RECORD DRAWING SET
JANUARY 2015

PROJECT TITLE
MYSTIC HARBOUR WWTP
UPGRADE AND PLANT EXPANSION

SHEET TITLE
PROCESS BUILDING
FLOOR & ROOF PLANS

PROCESS BUILDING – FIRST FLOOR PLAN
SCALE: 1/8" = 1'-0"

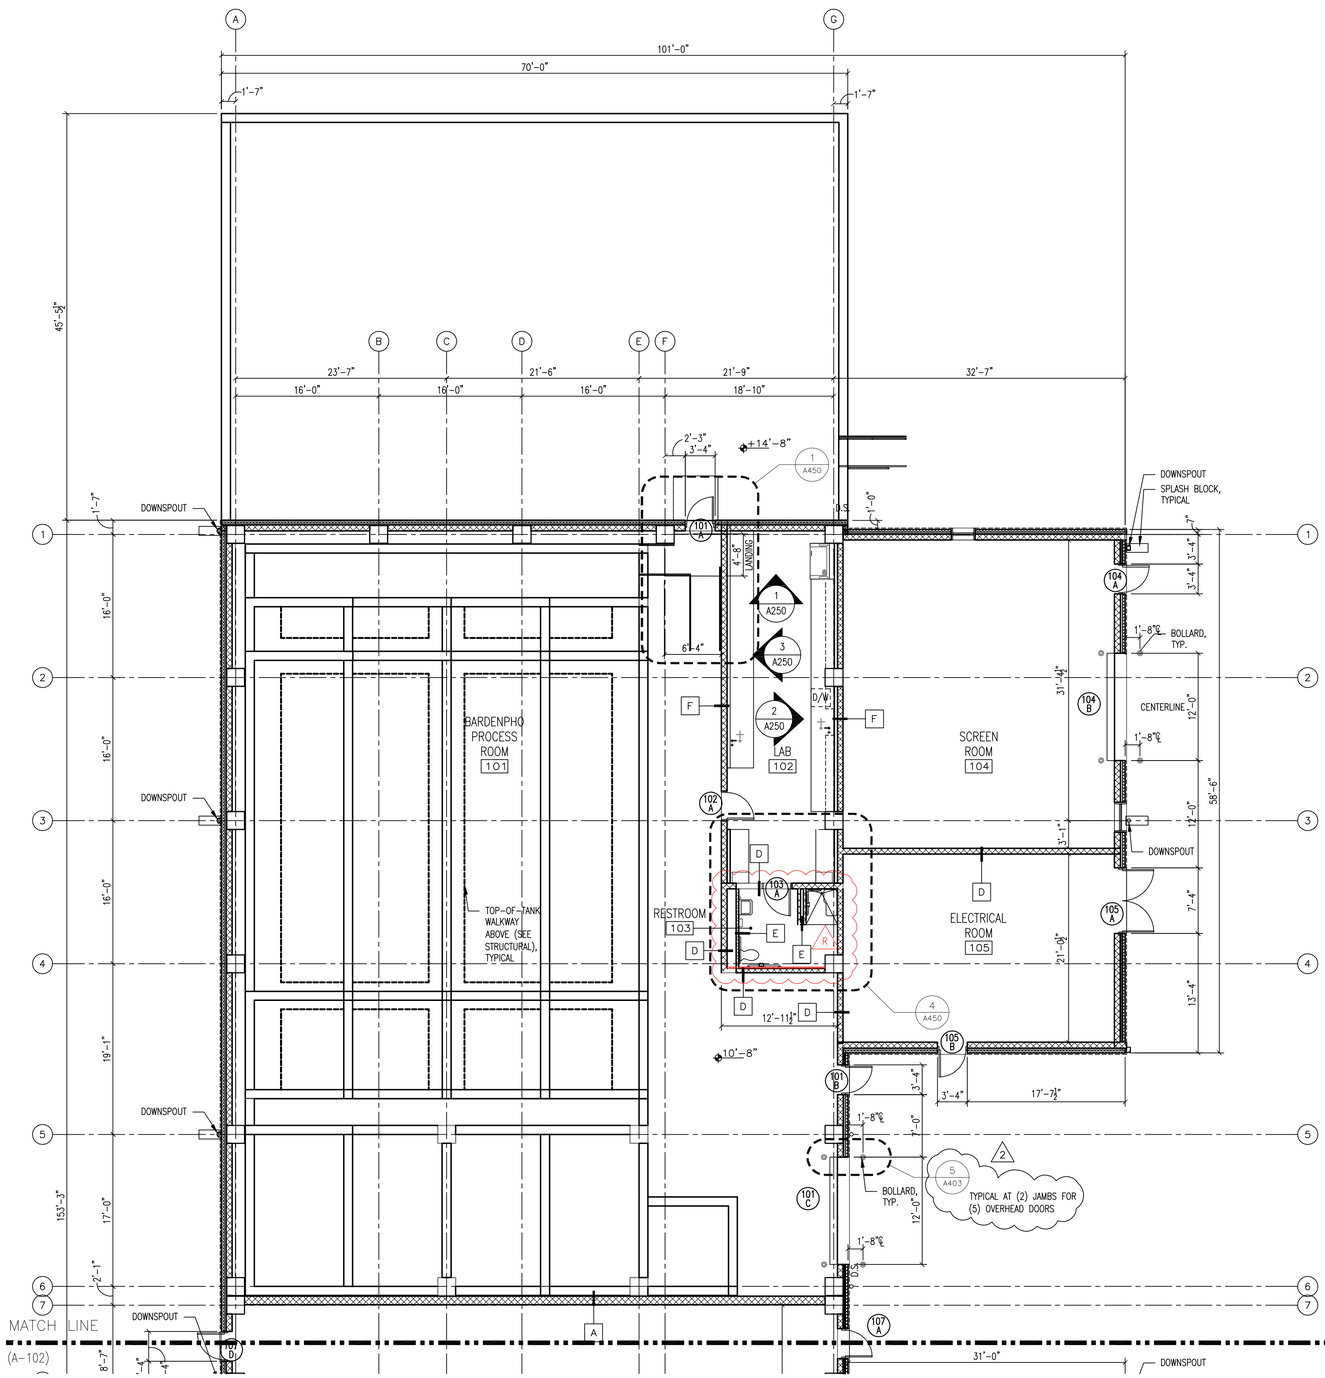
R 2 BATHROOM WALLS CHANGED FROM 4" CMU TO 6" METAL STUD WITH GREENBOARD DRYWALL.

DEMOLITION SITE PLAN
SCALE: 1" = 40'

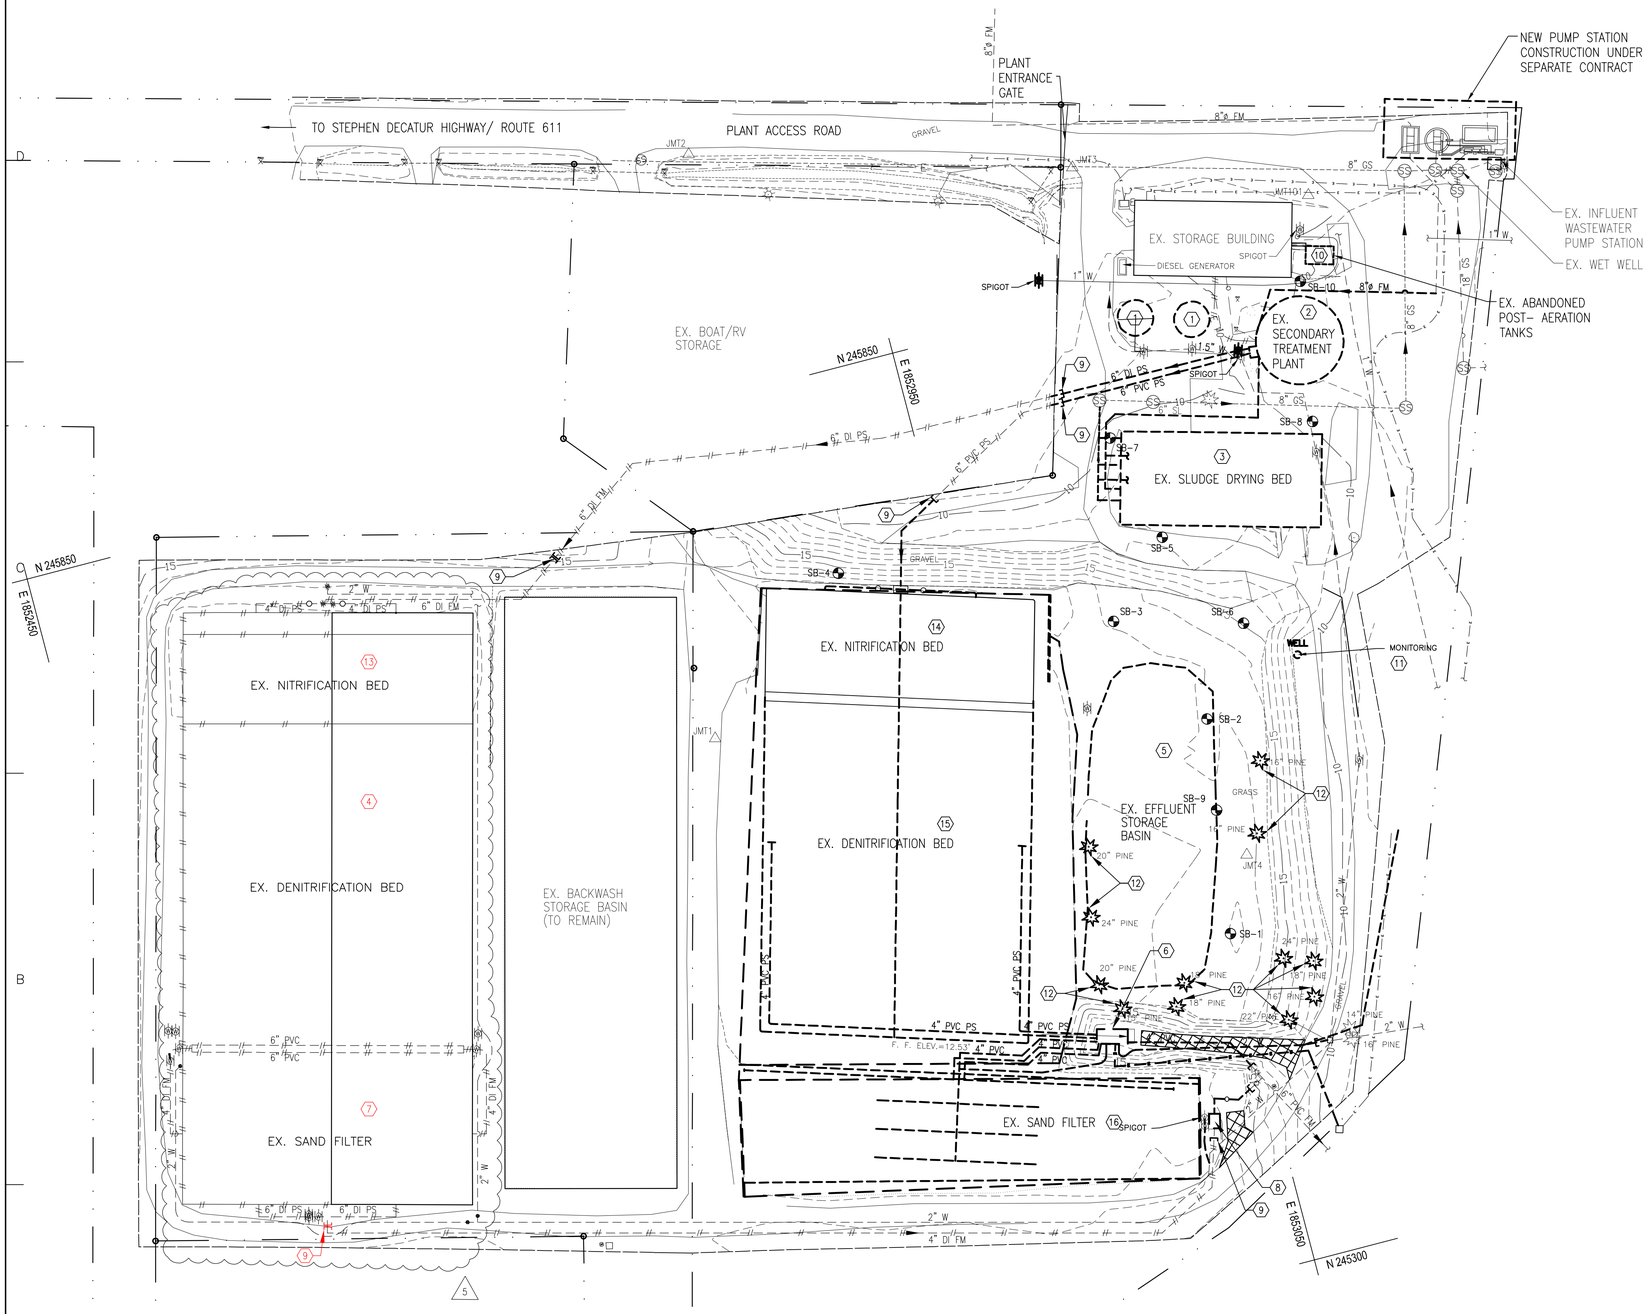
4. ~~ABANDON EXISTING DENITRIFICATION BED~~ BACKFILL EXISTING DENITRIFICATION BED WITH COMPACTED BACKFILL OR FILL MATERIAL. SEE SHEET C-504 FOR DETAILS. (5)

6. DEMOLISH EXISTING PUMP STATION 1 – SEE SHEET M-502 FOR DETAILS.
7. ~~ABANDON EXISTING SAND FILTER~~ BACKFILL EXISTING SAND FILTER WITH COMPACTED BACKFILL OR FILL MATERIAL. SEE SHEET C-504 FOR DETAILS. (5)

11. DEMOLISH EXISTING MONITORING WELL IN ACCORDANCE WITH ALL COUNTY & MDE REQUIREMENTS.
12. REMOVE EXISTING PINE TREES.
13. ~~ABANDON EXISTING NITRIFICATION BED.~~ BACKFILL EXISTING NITRIFICATION BED WITH COMPACTED BACKFILL OR FILL MATERIAL. SEE SHEET C-504 FOR DETAILS. (5)

PROPOSED SITE PLAN
SCALE: 1" = 40'

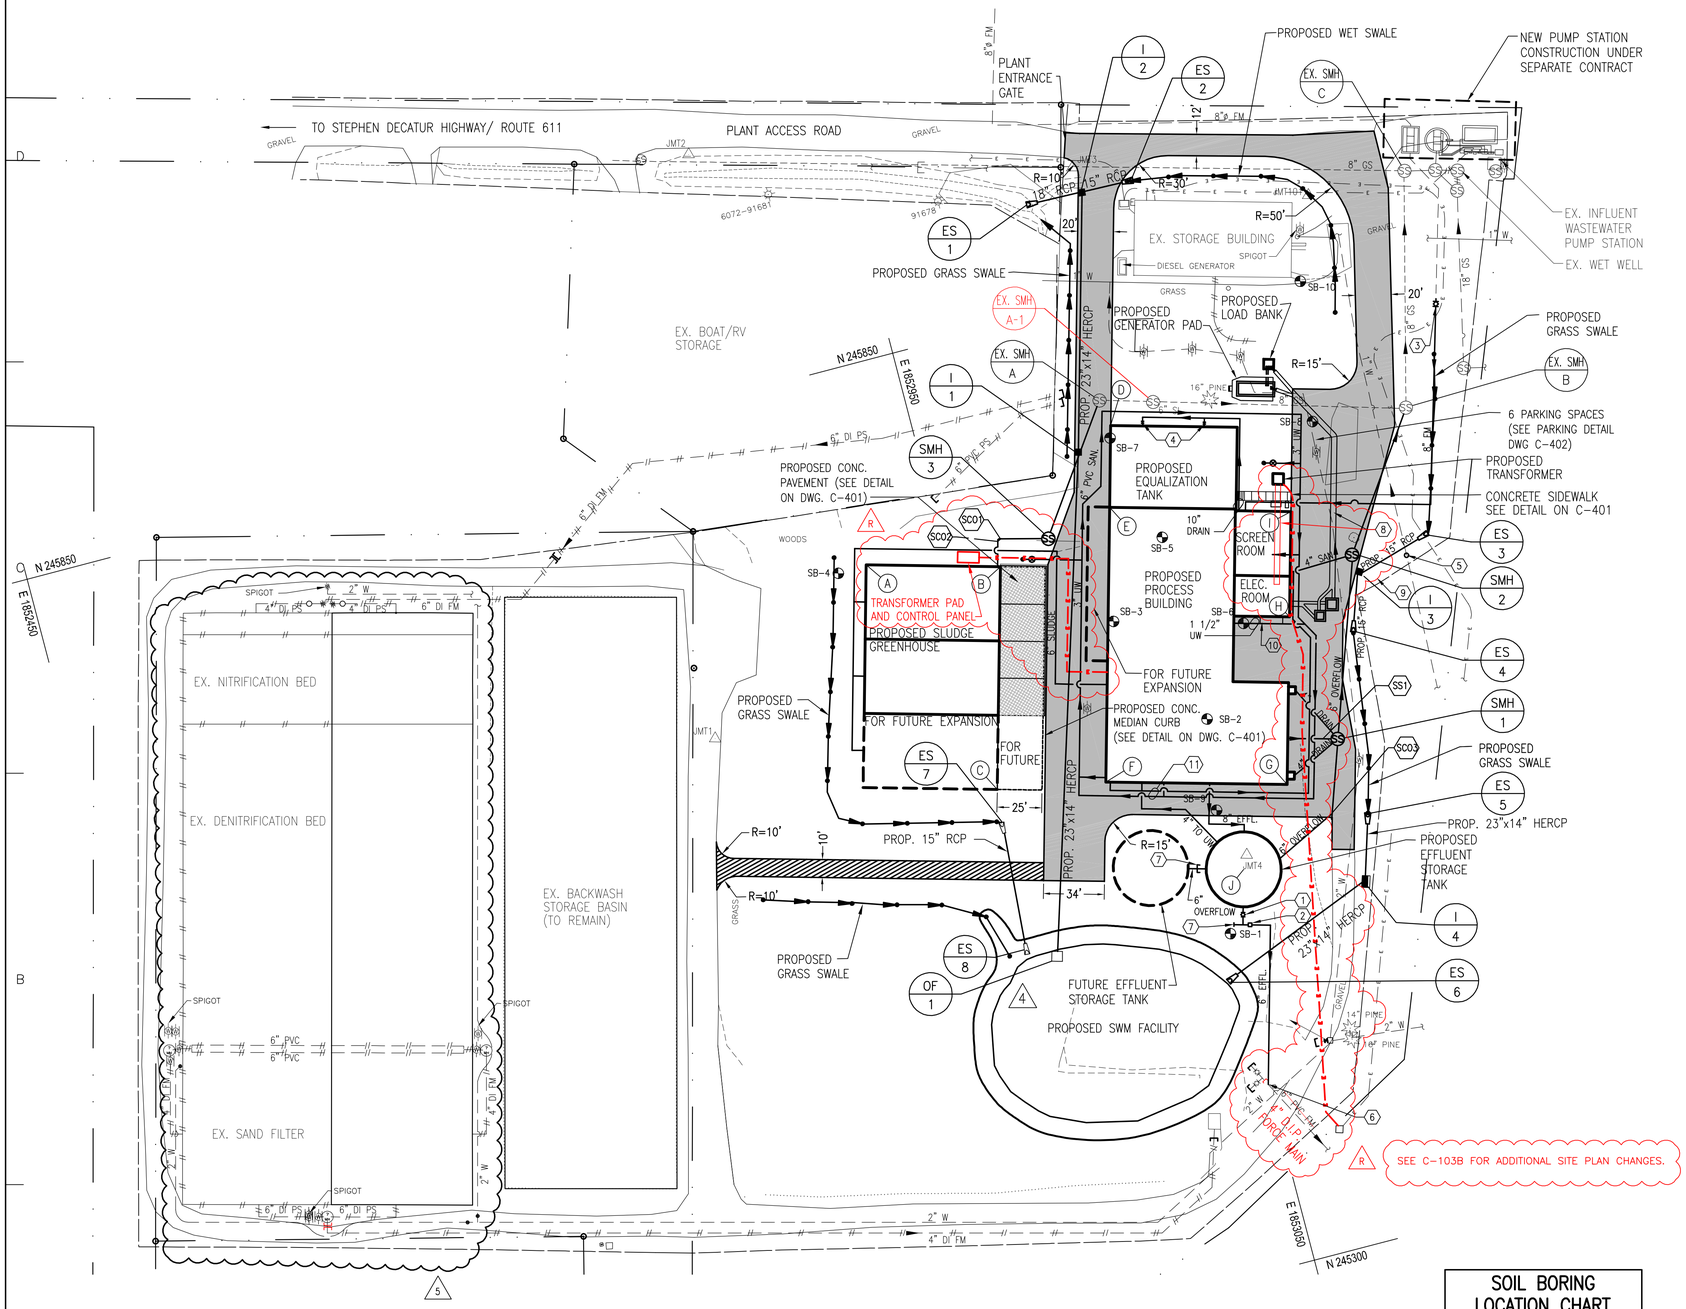
1. 6" PLUG VALVE
2. 6" MAGMETER
3. 8" PLUG VALVE WITH VALVE BOX
4. 10" PLUG VALVE
5. ~~2" VALVE W/ VALVE BOX~~ SHOWN ON C-103B (R)
6. TIE INTO EX. 6" PVC FM W/ 6" 45° FITTING
7. 6" BLIND FLANGE
8. ELECTRICAL DUCT BANK – SEE DRAWING E-104 FOR DETAILS.
9. ~~METER AND METER PIT BY COUNTY~~ SHOWN ON C-103B (R)
10. CONDENSING UNITS – SEE DRAWING H-101 FOR DETAILS.
11. (2) 3" PVC UTILITY WATER PIPES IN SHARED TRENCH.

1 E-110 CHEMICAL ROOM – POWER PLAN
SCALE: 1/4" = 1'-0"

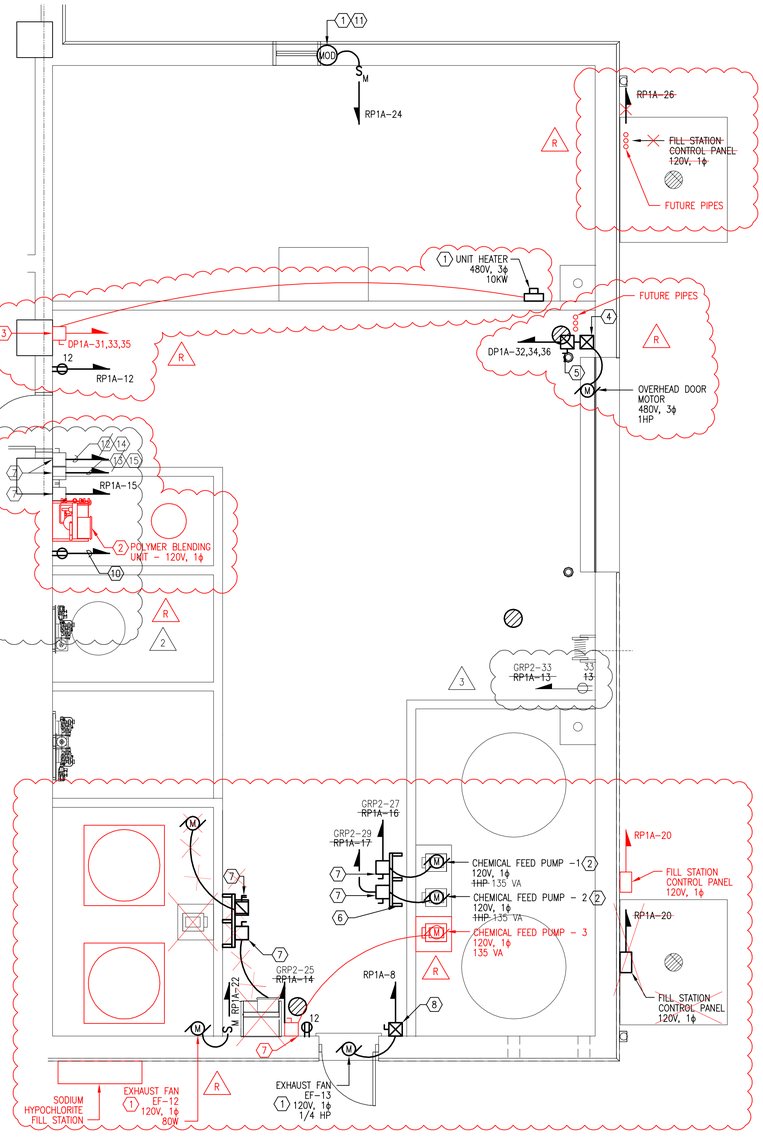
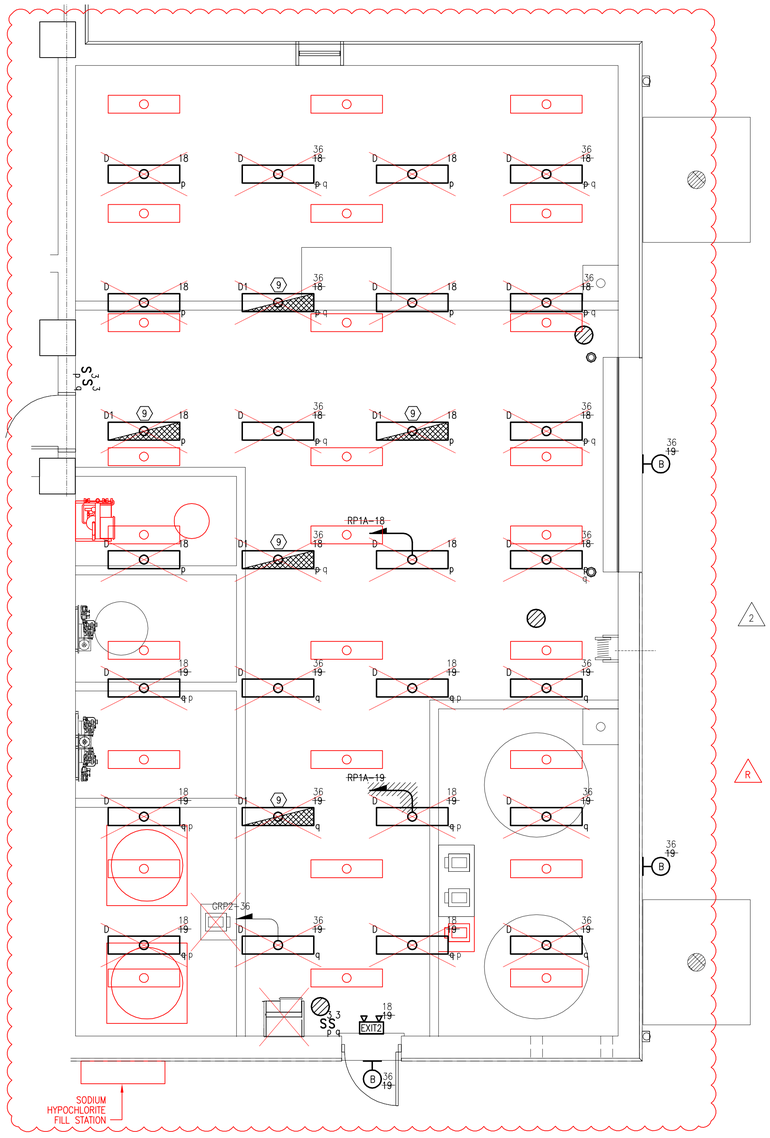
11. INTERLOCKED WITH EXHAUST FAN EF-13. ROUTE SUPPLY CIRCUIT THROUGH EF-13 STARTER.
12. ~~PROVIDE (2)#12 & (1)#12G IN 3/4" C FOR CITRIC ACID PUMP RECEPTACLE TO PERMEATE PUMP SKID-1 LOCATED IN PUMP ROOM. REFER TO DRAWING E-108 FOR LOCATION.~~

13. ~~PROVIDE (2)#12 & (1)#12G IN 3/4" C FOR SODIUM HYPOCHLORIDE PUMP RECEPTACLE TO PERMEATE PUMP SKID-1 LOCATED IN PUMP ROOM. REFER TO DRAWING E-108 FOR LOCATION.~~

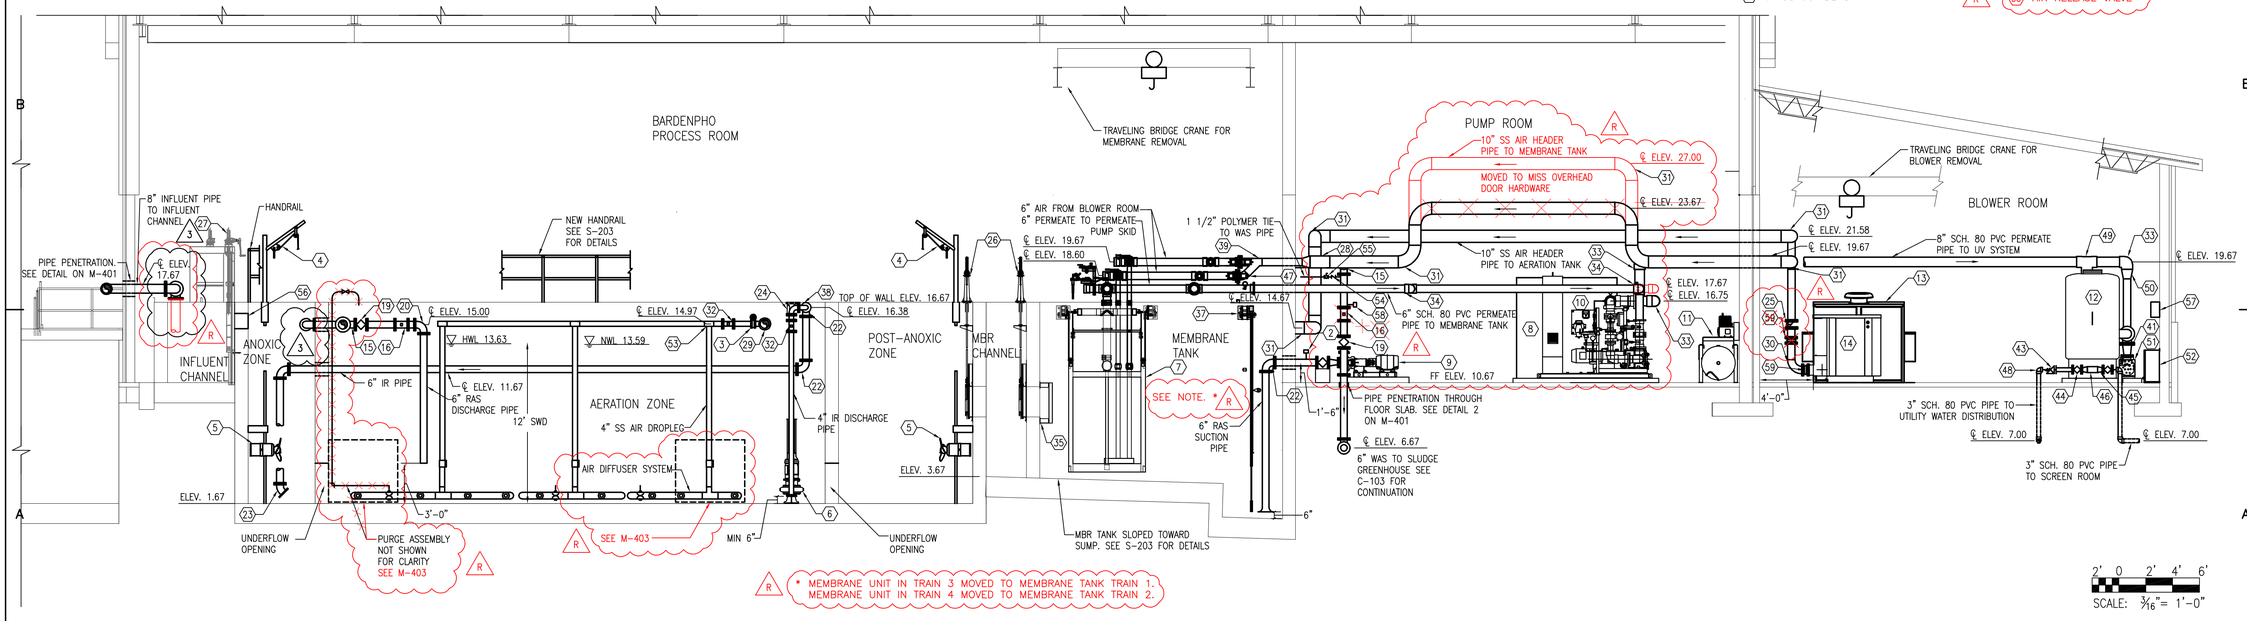
R * MEMBRANE UNIT IN TRAIN 3 MOVED TO MEMBRANE TANK TRAIN 1.
MEMBRANE UNIT IN TRAIN 4 MOVED TO MEMBRANE TANK TRAIN 2.
